SEGA OF AMERICA, INC.
Consumer Products Division

32X Hardware Manual Supplement 1

Doc. # MAR-32-R4-SP1-072694

(June 30, 1994)

Fig. 1 Configuration of 4 Word X 2 FIFO

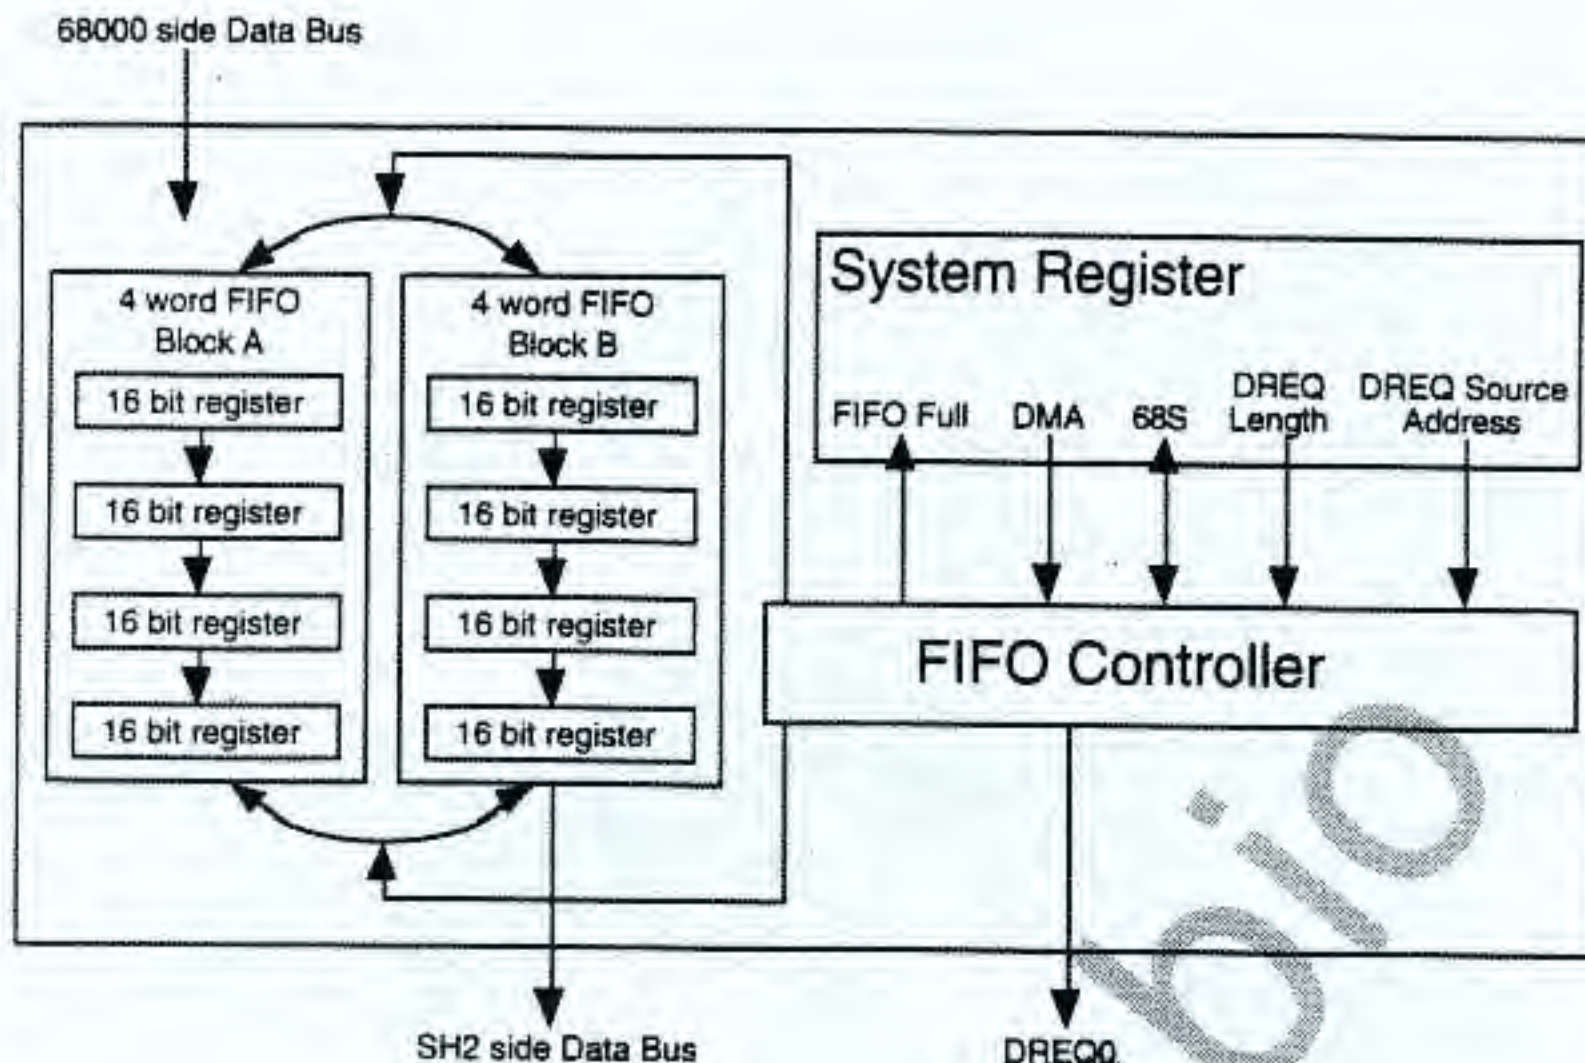
The configuration of FIFO is 4 words X 2 of block A FIFO and block B FIFO. Figure 1 shows the actual configuration. (The original configuration differs considerably but this configuration should be thought of as a type.) The operation is explained next. When FIFO is used, fetch DREQ by active H and edge, set the dual address mode and transfer destination to 4012H, then put the 1 time transfer size in word units. DACK is not used with the I/F chip, therefore any setting is all right. FIFO should be used in 4-word units. The 68000, after each kind of register of the DREQ relationship has been set, sets the DREQ control register in response to the transfer type.

The 68000 directly writes to FIFO and A1512H the data that you want to be transferred to SH2. FIFO block A is written to first because it is the first selected. Because all of FIFO block A is filled at the time 4 words are written, the write destination is switched to FIFO block B. After which, a FIFO block is switched each time it is filled. Further, for each 4 words written, the 68000 should write the next 4 words after confirming whether A15106H, bit 7 of the DREQ control register, and FIFO Full are 0. An operation in which more is written while FIFO is full becomes undefined. The I/F chip sets DREQ 0 in SH2 to H and activates DMA at the step that 1 FIFO block and 4 words are full. SH2 reads 4012H and FIFO by DMA, and the DREQ 0 output of the I/F chip becomes L. After this, DREQ 0 becomes H until the FIFO block, following a minimum 3 times in one direction, is empty. When 4 DMA transfers end, the SH2 read FIFO block switches. DREQ 0 becomes H when all the switched FIFO blocks are written by the 68000, and the DMA transfer request is

sent again as previously mentioned. The operation on the previous page is then repeated until DMA transfer is done the number of times that the length is written to A15110H and 68 to SH DREQ Length. FIFO Full occurs when 68000 selects the block that SH2 is reading or is going to read to the write destination. When all transfer of the 68000 side has ended, 68S of bit 2 of A15106H automatically becomes 0 and FIFO access of the 68000 side ends. Then 68000 ignores anything written to A15112H and FIFO. DMA transfer requests are sent by DREQ 0 until all DMA transfer for SH2 have ended. Thus, the communication register should be used when SH2 side request end must be reported from the SH2 side to 68000 since it is not known whether or not DMA transfer of the SH2 side has ended, even if 68S is 0. If 68S becomes 0 while 68000 is transferring, DMA transfer can be forcefully interrupted, but because the SH2 side DMA transfer, during that time, forces DREQ 0 to become L, operation after that is undefined. The value of the counter that indicates the write destination of FIFO itself is also undefined. Thus, only when systems such as VRESET are reset or when a SH2 side operation is controlled by 68000 should you use DMA forced end by writing 0 to 68S. On the other hand, when a system has been reset, 68S force-clear of the transfer in progress can be performed and you should, therefore, write a 0 to 68S.

Fig. 2 Block Diagram of SH2, 68000, I/F Chip and VDP Chip

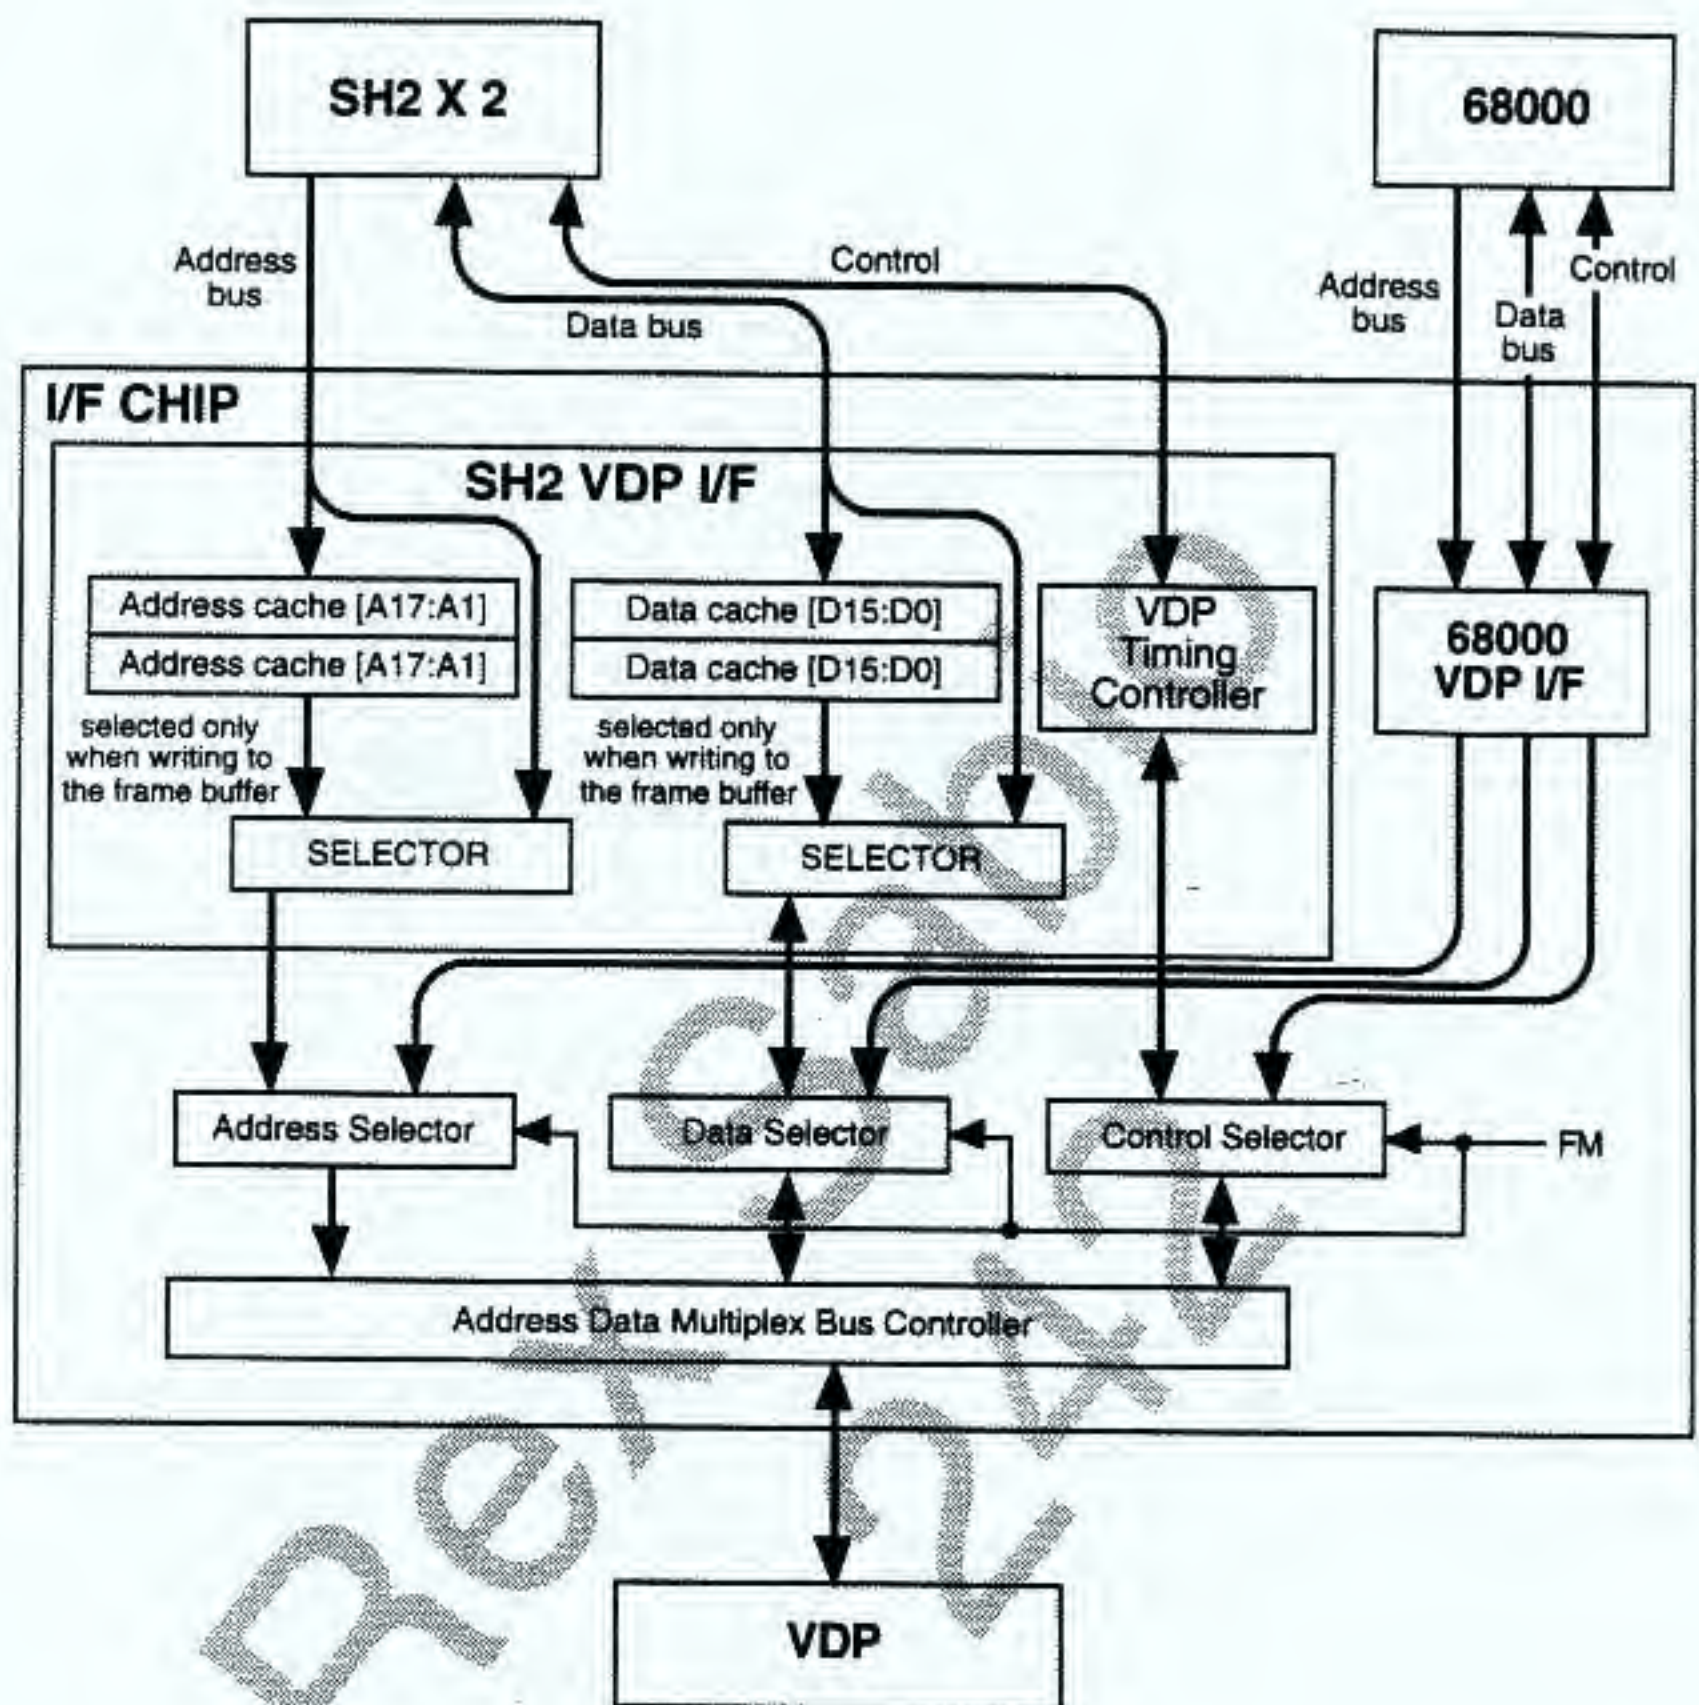
The 32X VDP is done through the VDP I/F circuit of the I/F chip to the VDP chip. VDP switches access of the 68000 and SH2 simply by A15100H (4000H for SH2) of bit 15 and the FM bit. Figure 2 shows a block diagram of the SH2, 68000, I/F chip and VDP chip. The SH2 side has a 2 word write cache for the frame buffer and can actually write up to a continuous 4 words by 3 clocks existing in the minimum cycle during the external access of SH2. Reading to other VDP registers, palettes, and all VDP requires at least 7 clocks. When reading to the VDP or writing to the VDP register and palette immediately after writing to the frame buffer, after all the data currently in the cache is transferred to the VDP side, compared to a normal independent access, a large number of waits are entered against the SH2, thus prolonging the access time.

One point of caution is when, in the worst case scenario, transfer to the VDP becomes distorted and SH2, 68000, as well as the VDP, lock up because access authorization is forced to the 68000 side while the VDP I/F circuit is writing to the frame buffer for VDP if the FM bit is set to 0 immediately after SH2 finishes writing to the frame buffer. Accordingly, when switching the FM bit, it must be done after reading to the frame buffer, VDP register or palette (or writing to the VDP register and palette) and all cache data is transferred to the VDP.
